| VEHICLE MODEL | : CX45, CX35, TX40, TX45, TD925US, TDX25US |
| BULLETIN TYPE | : Field change program |
| DATE | : February 08th, 2019 |
| SUBJECT | : Improper operating coolant surge tank filler cap |

|  <p>015083B</p> <p>Figure 1</p> | | |

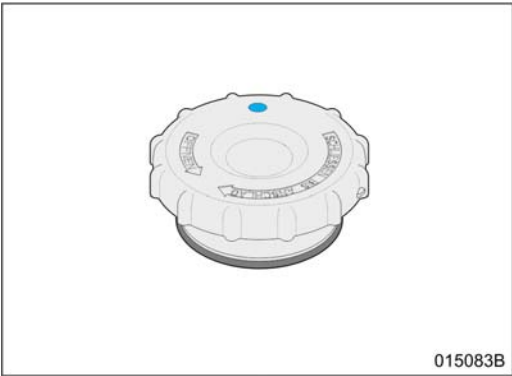
We received a number of complaints regarding frequent coolant loss at the overflow line of the coolant surge tank filler cap. Tests have shown that this is due to the installation of a batch of improper operating filler caps. On these filler caps, the pressure relief valve does not close firmly on the filler neck seat, causing unnecessary coolant loss through the overflow line of the filler cap.

To solve this problem, Van Hool organises a field change program involving the installation of a new filler cap. For visual identification purposes, the new filler cap has been marked **blue**.

|  <p>015083B</p> <p>Figure 1</p> | | |
|--|-------------|----------|
| 11116431 | Filler cap | 1 |
